PROP-009 rev A

35 Liverpool Road
 Proposed Front (North) Elevation
 Scale - 1 to 50 @ A3
 17 January 23

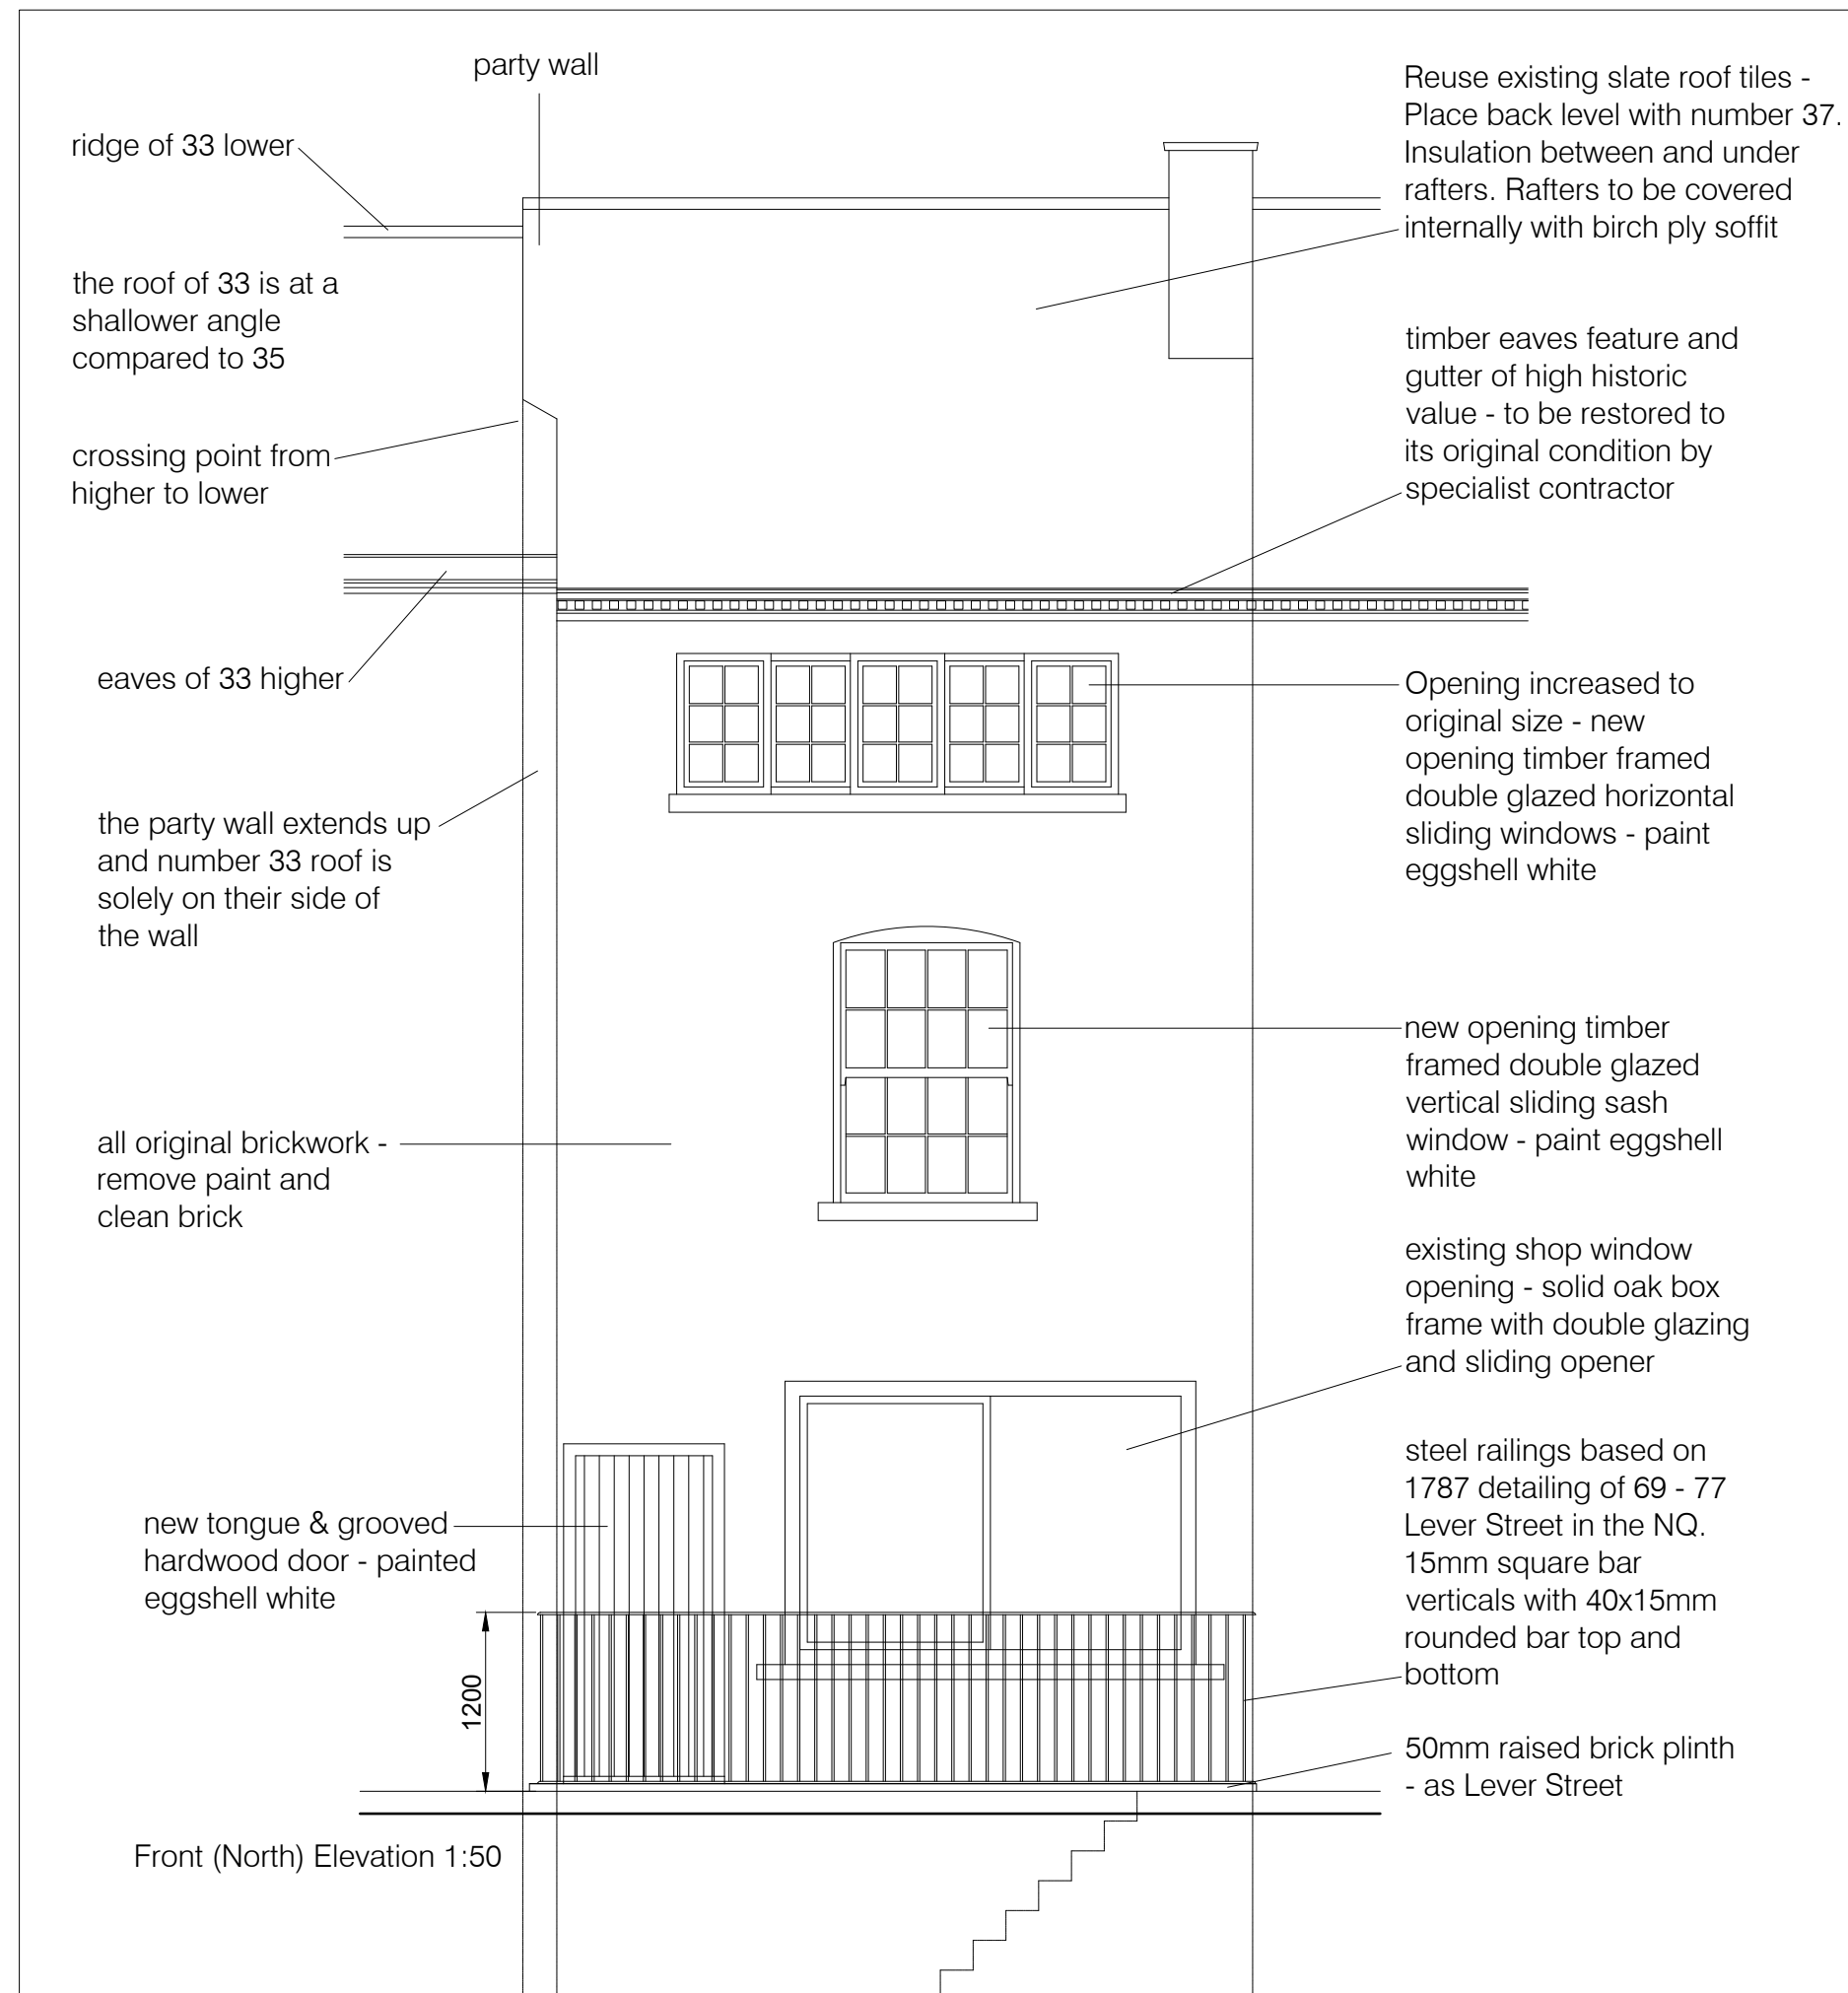
Revisions - Proposal for large '35' removed
 Traditional timber windows added to first and second floors
 Traditional railings added to basement steps down
 External front access through existing roof to balcony - removed
 Glazed openings to front of roof removed
 Glass lantern removed
 Alterations to existing purlins omitted
 Position of insulation lowered so slate tiles remain at existing level
